Date: February 25, 2020

Subject: Type 26 Torpress Actuator Pad Change to One-Piece Design

OLD MULTI-PIECE DESIGN		NEW ONE-PIECE DESIGN	
Old Part Number		New Part Number	
700330 (RH)	700332 (LH)	703033-RH	703033-LH

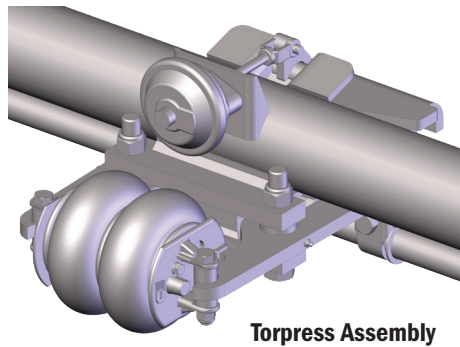
In keeping with Dexter's commitment to product innovation, we are pleased to communicate a change from a multi-piece weldment to a one-piece design for the type 26 Torpress actuator pads on SMART-STEER axles. There is no impact to fit, form, or function of this new design. Old pads and new pads are interchangeable in the field. This change will be implemented immediately to enhance production efficiency and bolster the reliability of the product.
